## V2500-A5 SERIES PROPULSION SYSTEMS SERVICE BULLETIN

This document transmits the Revision 1 of Service Bulletin V2500-ENG-80-0021

STARTER/TAI DUCT SYSTEM – REPLACEMENT OF BEARING LINK ASSEMBLIES (FOR CONTROLLED SERVICE USE)

Replacement of Starter Duct Bearing Link Assemblies  
Figure 1

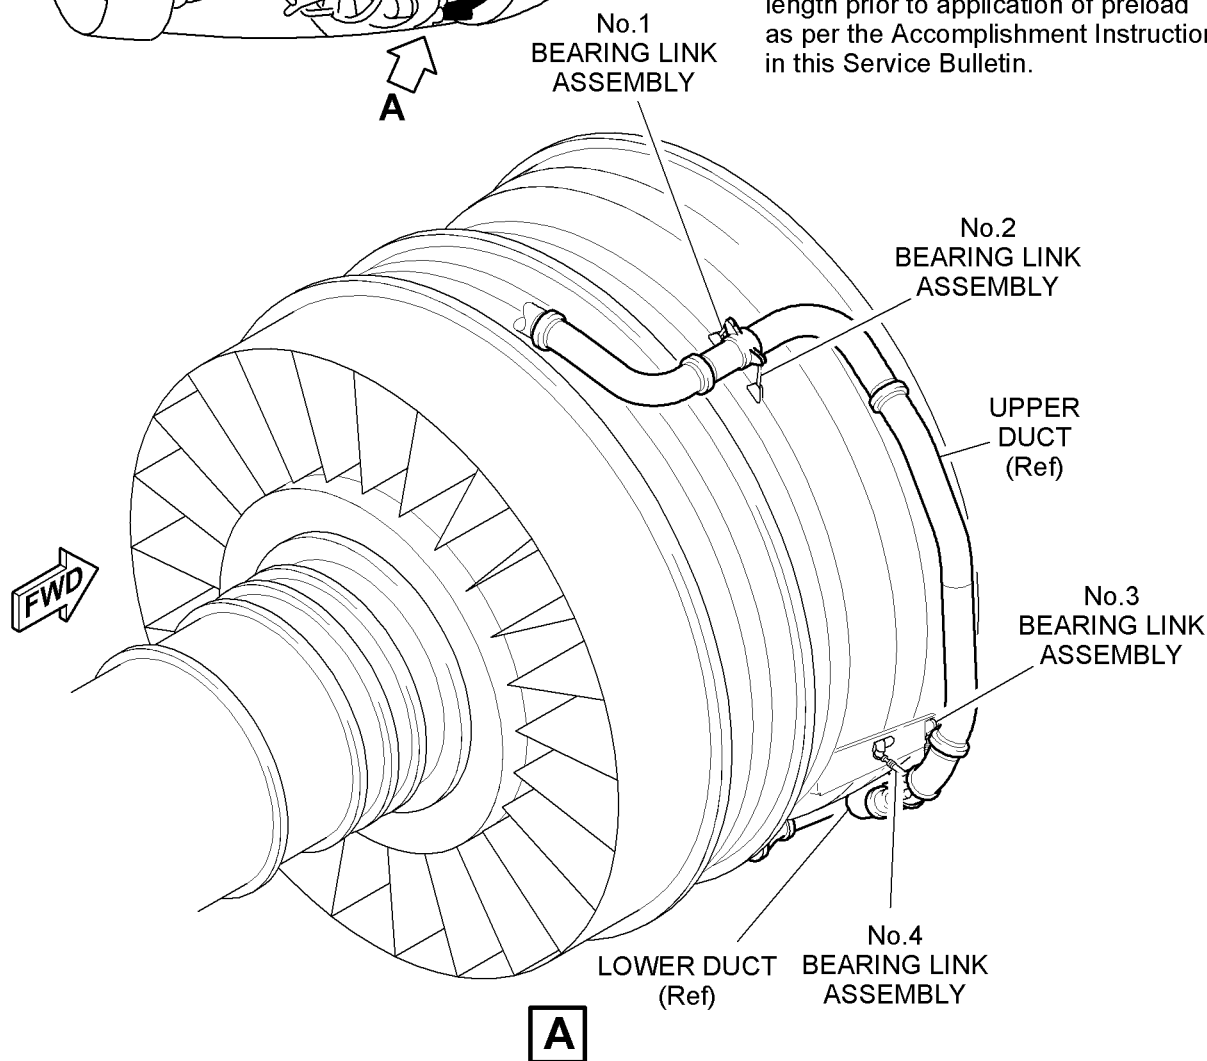
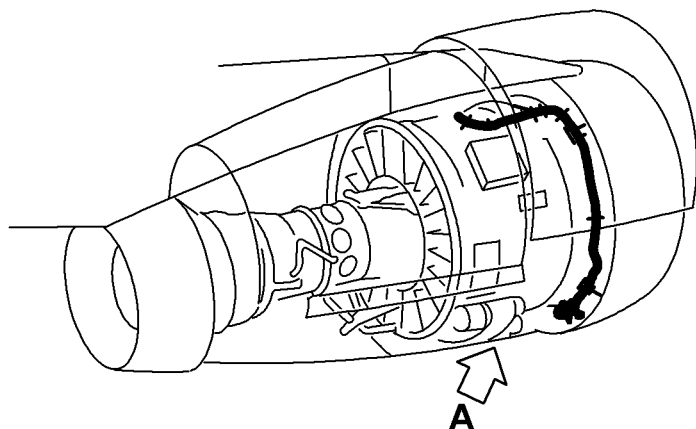
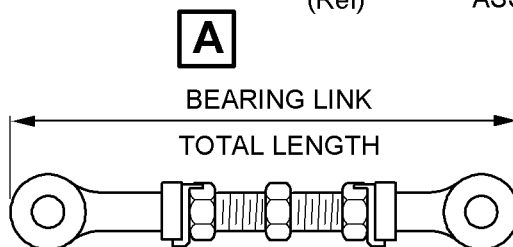
Part A – Replacement of the bearing link assemblies on the Air Starter – LH or RH Engine

- (a) Adjust the central connecting rod nut at position one to make the overall length of the bearing link an approximate nominal length of 4.65 in. (118,00 mm).

- (b) Adjust the central connecting rod nut at position two to make the overall length of the bearing link an approximate nominal length of 5.55 in. (141,00 mm).

- (e) Torque the central adjustment nut on the connecting rod at position one to 25 lbf in. (2.8 Nm). Apply the torque so that it will reduce the length of the bearing link. Refer to the Aircraft Maintenance Manual, TASK 70-23-11-911-013.

- (j) Adjust the length of the bearing link at position three to the nominal length of 3.04 in. (77.4 mm) as shown.

- (k) Adjust the length of the bearing link at position four to the nominal length of 4.59 in. (116.5 mm) as shown.

- (n) If required, shorten the length of the bearing link at position three by the application of a half turn (180 degrees) in a clockwise direction. This will cause a positive axial preload when the link is re-installed.

- (o) Shortened the length of the bearing link at position four by the application of a full turn (360 degrees) in a clockwise direction. This will cause a positive axial preload when the link is re-installed.

Replacement of TAI Bearing Link Assemblies  
Figure 2

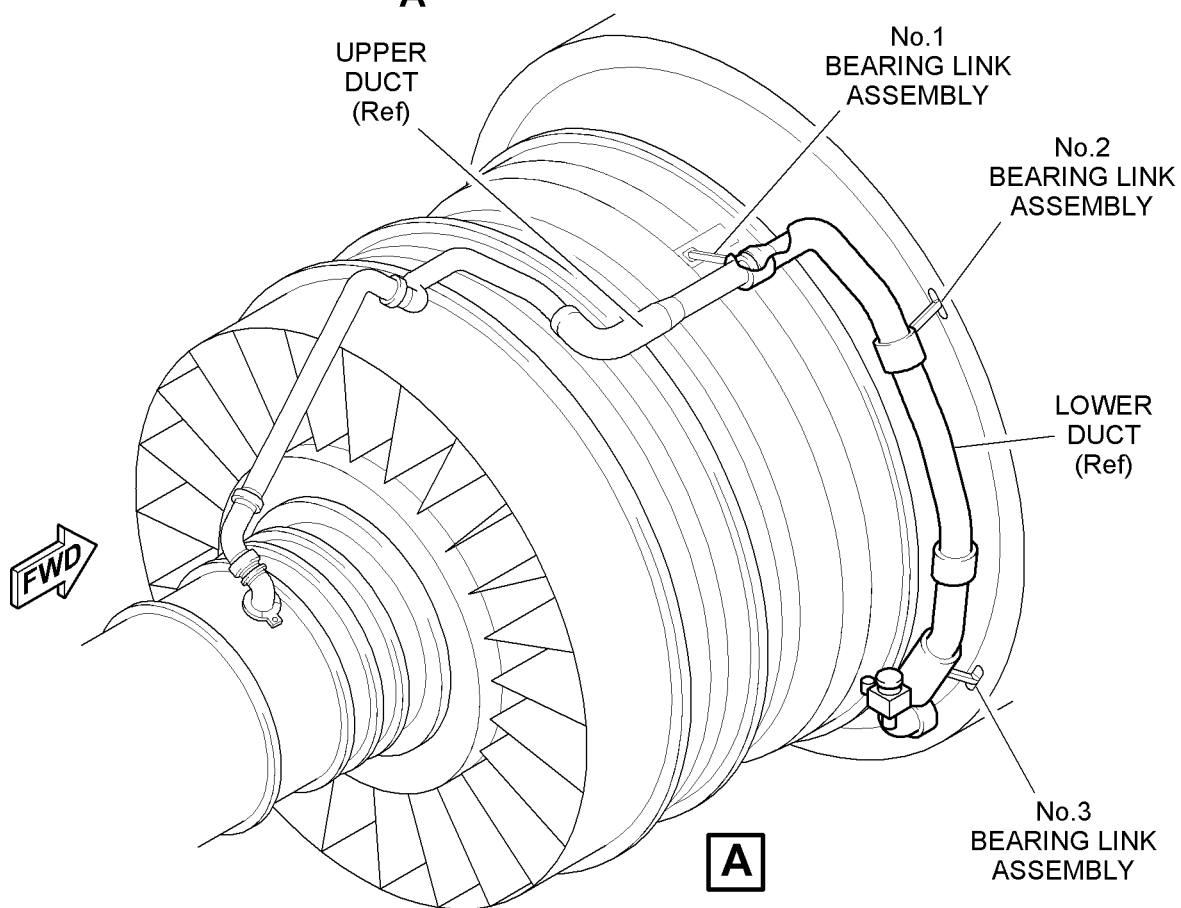
#### Part B – Replacement of the bearing link assemblies on the TAI Ducts – LH or RH Engine

- (a) Adjust the central connecting rod nut at position one to make the overall length of the bearing link an approximate nominal length of 5.37 in. (136.5 mm).
- (b) Adjust the central connecting rod nut at position two to make the overall length of the bearing link an approximate nominal length of 5.84 in. (148.34 mm).
- (c) Make further adjustments to the bearing link at position one to set the link to a length that just permits you to put in the bolts at the end of the bearing link. Tighten the bearing link bolts in accordance with the Aircraft Maintenance Manual, TASK 80-13-49-400-010.
- (d) Make further adjustments to the bearing link at position two to set the link to a length that just permits you to put in the bolts at the end of the bearing link. Tighten the bearing link bolts in accordance with the Aircraft Maintenance Manual, TASK 80-13-49-400-010.

**NOTE:** Make sure that there is a minimum clearance of 0.23 in. (6.0 mm) between the gimble insulation and the fan case after you torque the connecting rods.

- (j) Adjust the length of the bearing link at position three to the nominal length of 4.20 in. (106.68 mm) as shown.
  - (k) If required, shorten the length of the bearing link at position three by the application of a half turn (180 degrees) in a clockwise direction. This will cause a positive axial preload when the link is re-installed.

REMOVE AND REPLACE  
EXISTING BEARING LINKS AND  
ATTACHING HARDWARE
